PRATT & WHITNEY CANADA
SERVICE BULLETIN

P&WC S.B. No. 41119R2

TURBOSHAFT ENGINE
IGNITION EXCITER - REPLACEMENT OF

PT6C-67C, PT6C-67C1

Ignition Exciter - Part Progression
Figure 1

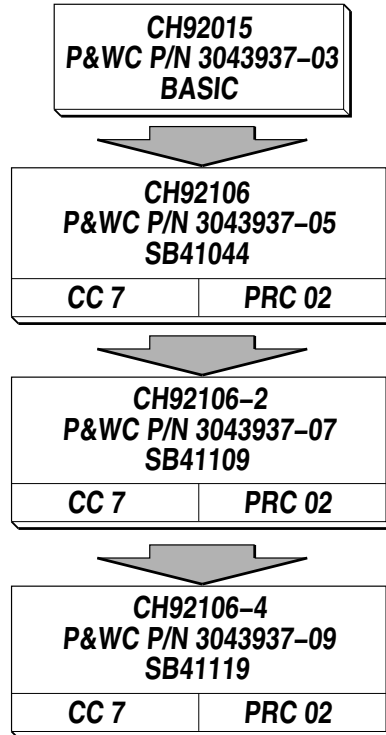
The ignition exciter spider switch is no longer available.

The ignition exciter spider switch has been obsoleted.

Replace the ignition exciter with one that has an available spider switch.

<u>New P/N</u>	<u>Keyword</u>	<u>Old P/N</u>	<u>Qty</u>	<u>Est. Unit List Price (\$US, 2021)</u>	<u>Instructions Dispositions</u>
	Ignition Exciter (0AFL4) P&WC P/N 3043937-07	CH92106-2	1		(A)(B)
CH92106-4	Ignition Exciter (0AFL4) P&WC P/N 3043937-09		1	Quote	(A)

(A) TWO WAY INTERCHANGEABLE (ATA200 Explanation Code 02): The old or the new parts can replace the old or the new part.
